CITY PLAN COMMISSION STAFF REPORT

LivSmart Studios KCI

CD-CPC-2024-00019

Non-Residential Development Plan

SITE PLAN

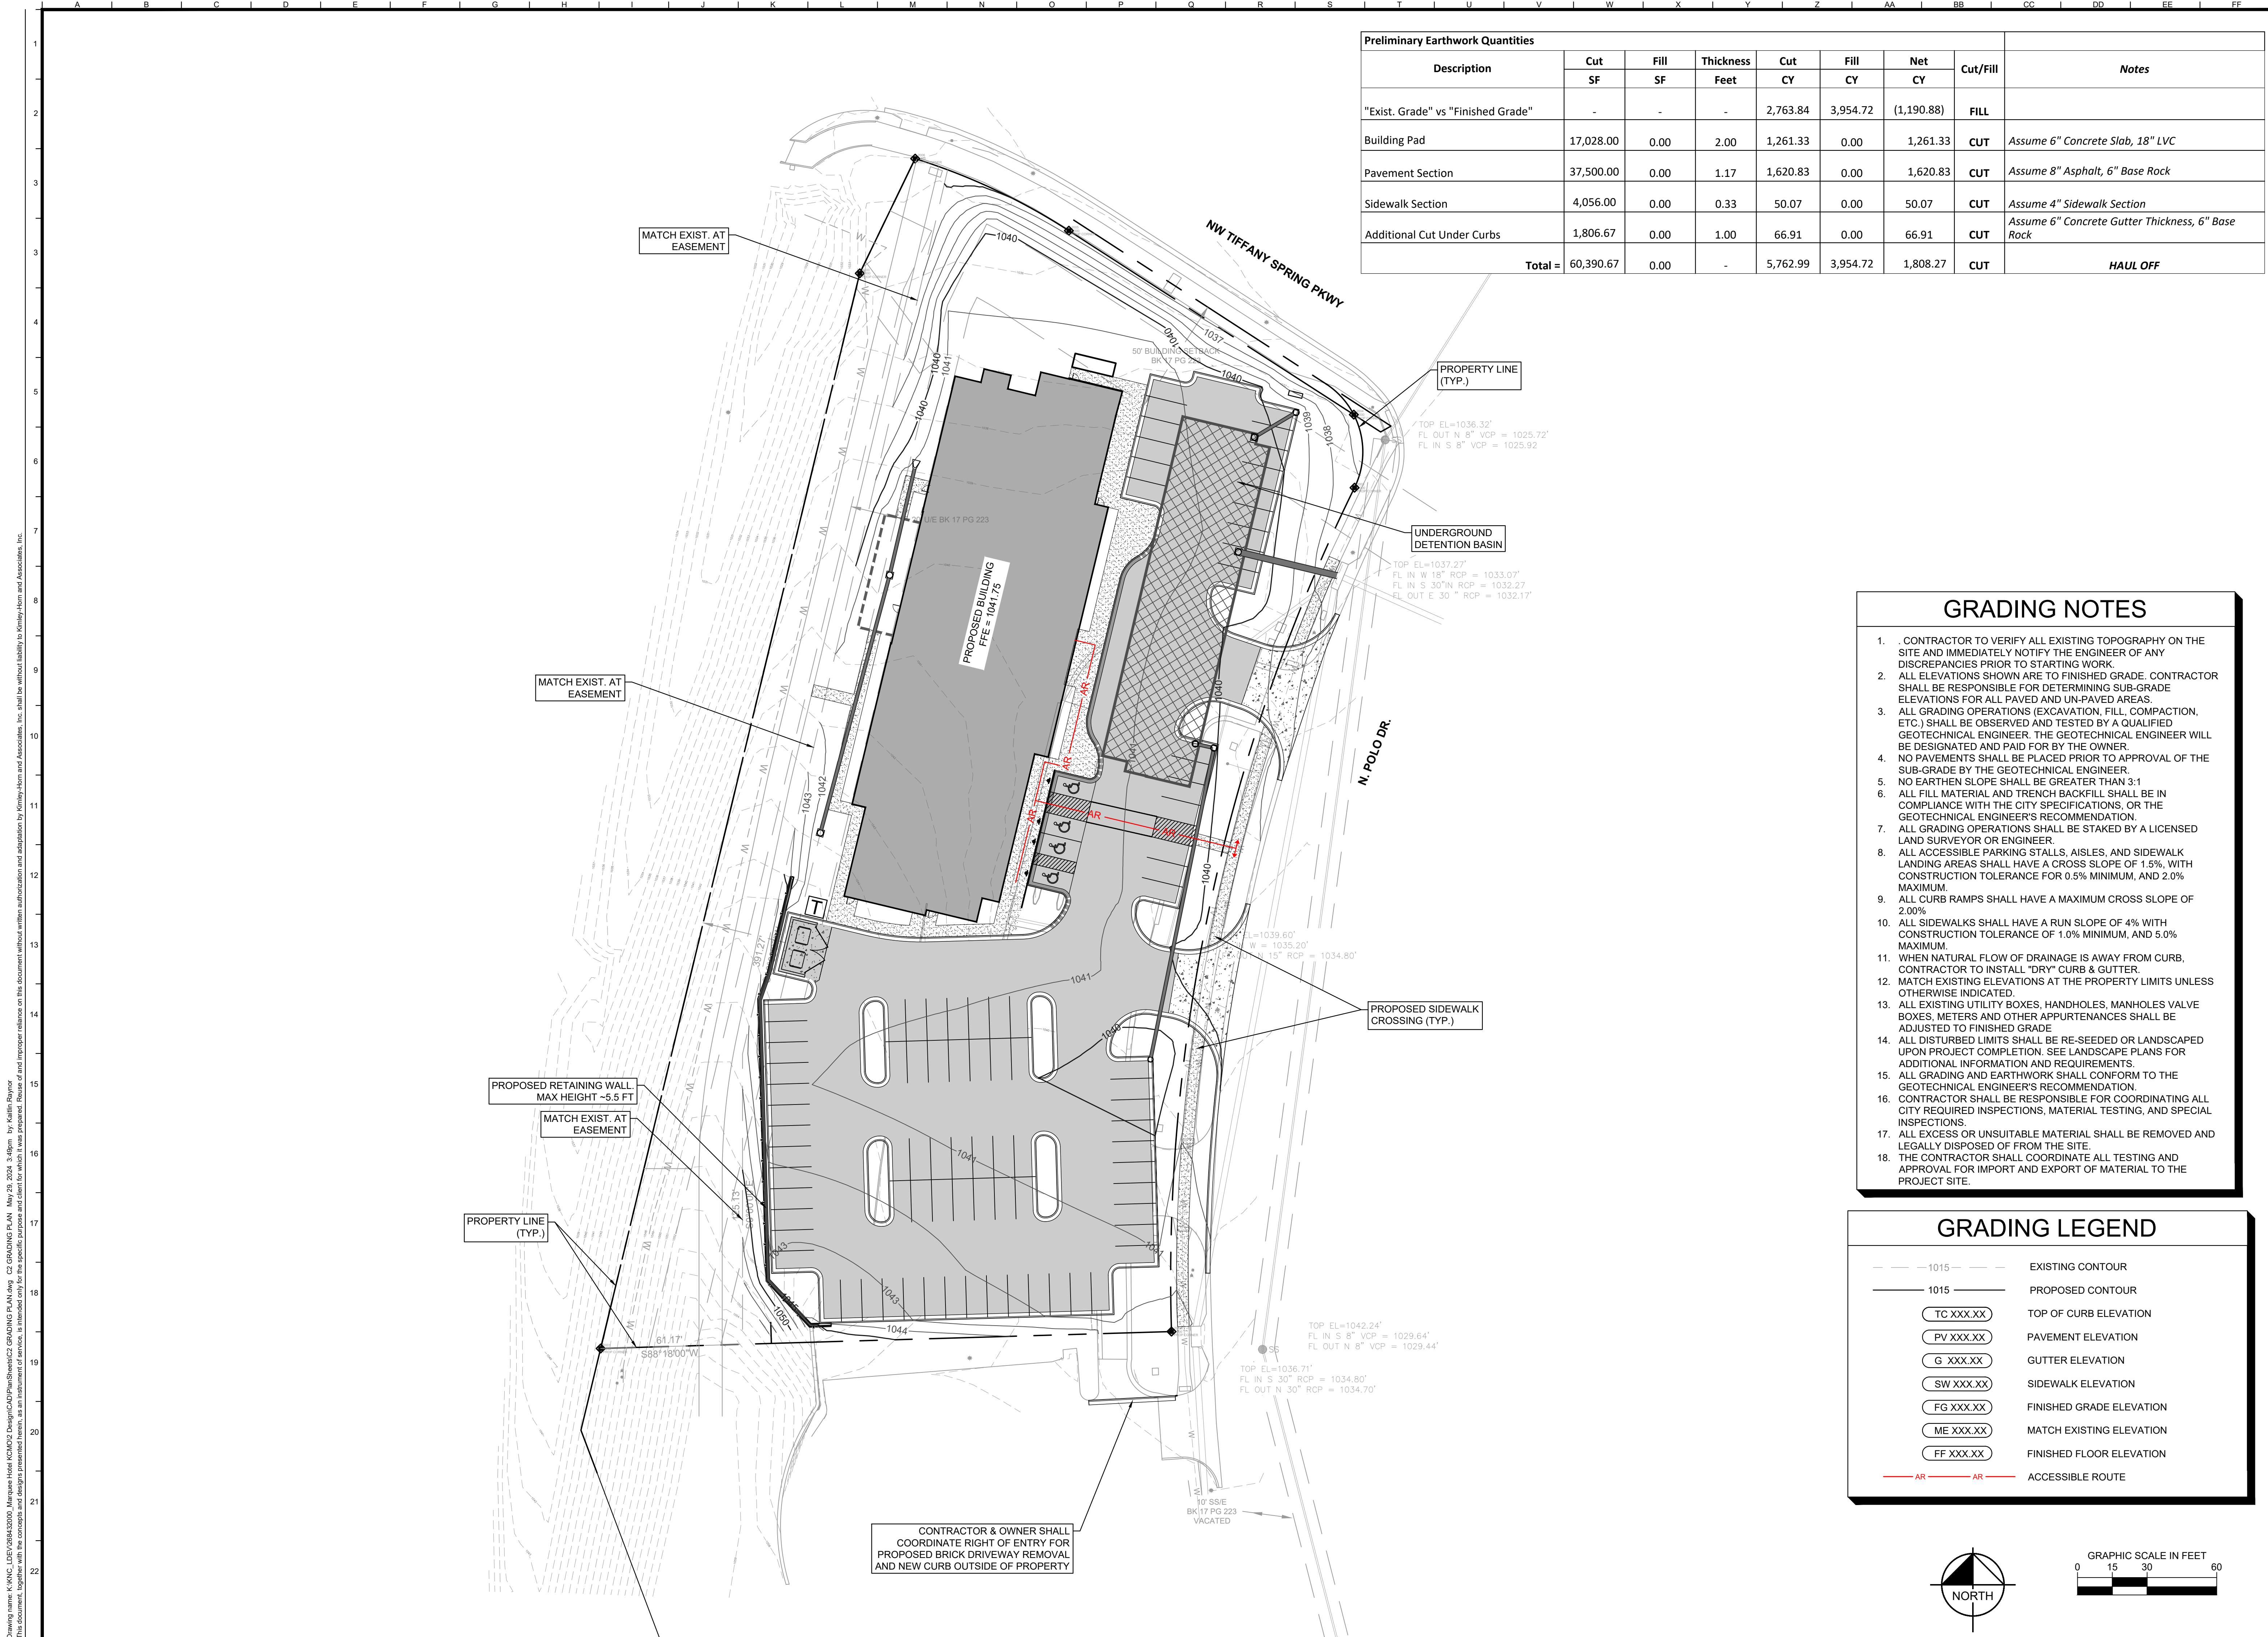
Surface Parking – Boulevard and Parkway Standards (88-323-02-B): If adjacent to and within 150 feet of a parkway, parking located on the side of the building shall be set back a minimum of 10 feet behind the front building line or 30 feet from the right-of-way, whichever is greater. The site plan shows parking on the east side of the building that is not compliant with this section of code. The applicant will be required to apply for and receive approval of a variance to the parkway standards.

7. The developer shall apply for and receive approval of a variance to 88-323-02-B-2, prior to certificate of occupancy. Should a variance be denied by the Board of Zoning Adjustment the developer shall revise the plans to be compliant with the Zoning and Development Code.

- PER SECTION 88-323-02-B, IF ADJACENT TO AND WITHIN 150 FEET OF A PARKWAY, PARKING LOCATED ON THE SIDE OF A BUILDING SHALL BE SET BACK A MINIMUM OF 10 FEET BEHIND THE FRONT BUILDING LINE OR 30 FEET FROM THE RIGHT-OF-WAY, WHICHEVER IS GREATER. WITH THE PLATTED 50' BUILDING SETBACK FROM NW TIFFANY SPRING PARKWAY, THIS REQUIREMENT CREATES A 60' PARKING SETBACK (10' FURTHER THAN THE PLATTED SETBACK). DUE TO SITE CONSTRAINTS, THE PLAN IS SEEKING A VARIANCE FROM THE ABOVE SECTION, TO ALLOW PARKING WITHIN 10' OF THE EXISTING R/W LINE. IF THE VARIANCE IS NOT GRANTED BY THE BZA, THE PLAN WILL BE REVISED TO RECONFIGURE THE 10 PARKING SPACES IDENTIFIED IN THIS PLAN, LOCATED OFF THE NORTH-EAST CORNER OF THE BUILDING.

| | DENOTES PARKING STALLS TO BE RECONFIGURED IF VARIANCE IS NOT GRANTED BY BZA |

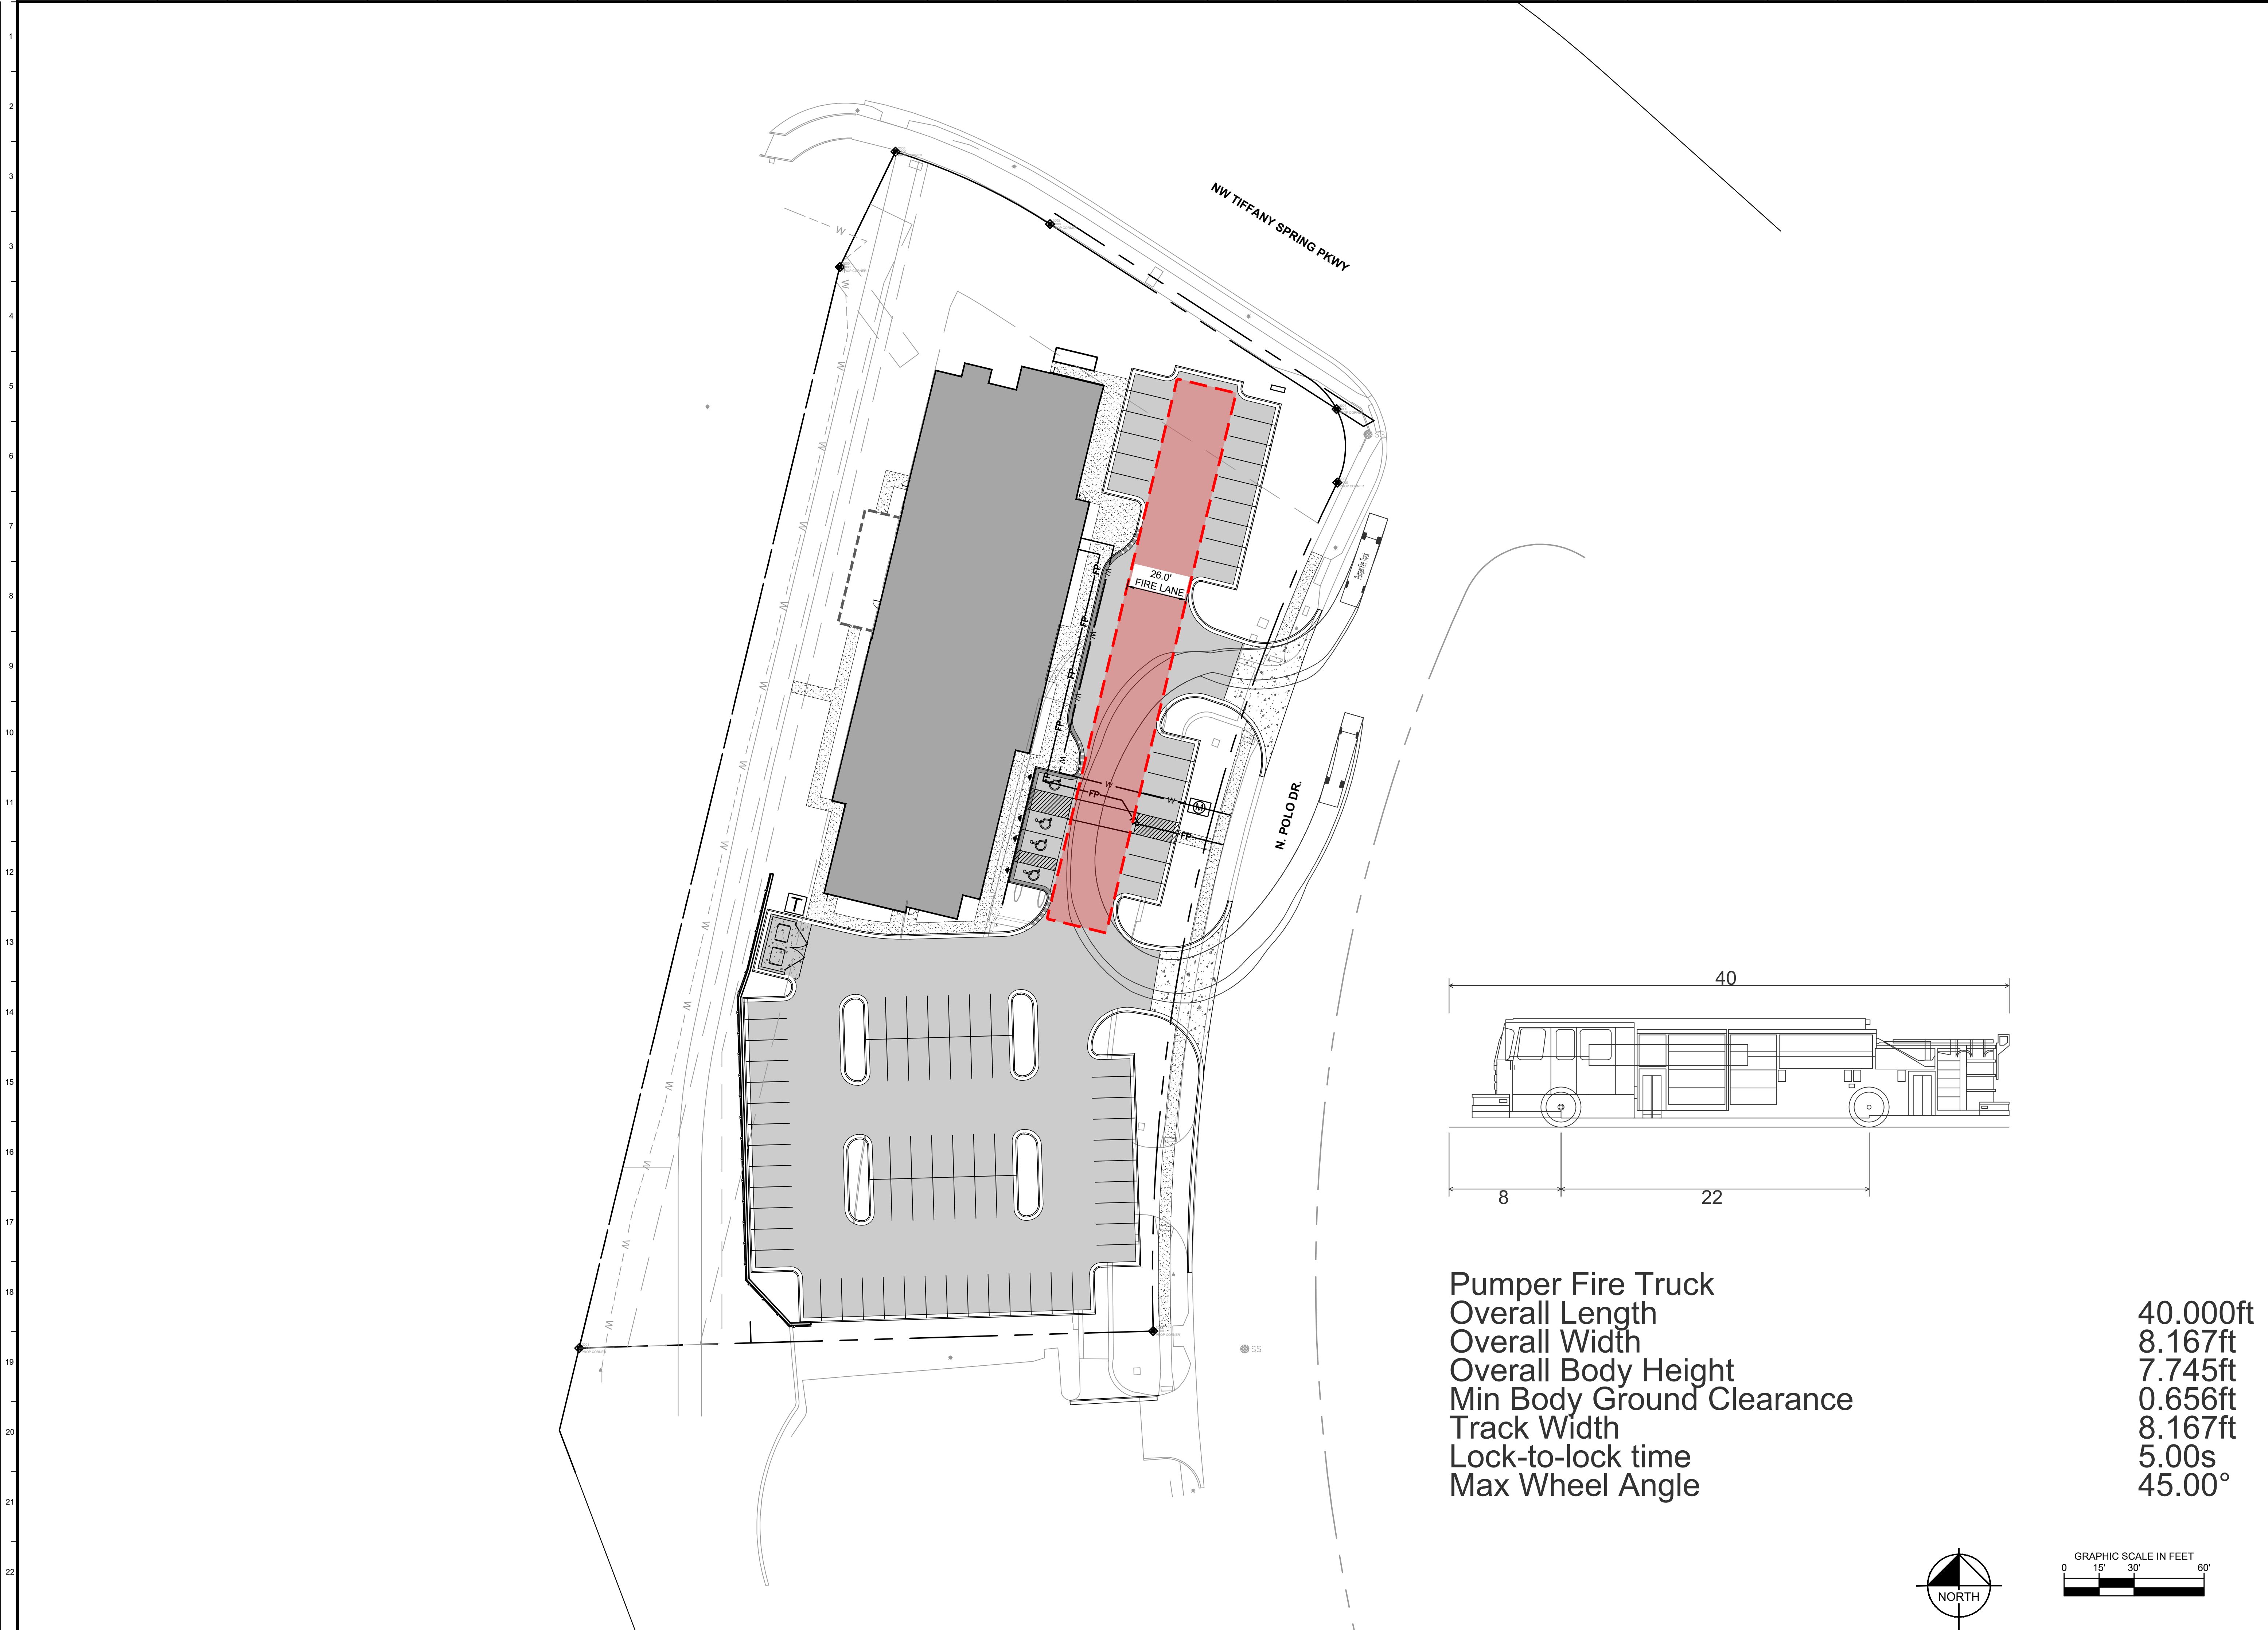
21. Aerial Fire Apparatus access roads shall be provided for any building that is 30 feet in height or greater. Aerial Fire Apparatus Roads are a minimum 26 feet wide, at least 15 feet away from the building but not more than 30 feet from the structure. (IFC-2018 § D105).
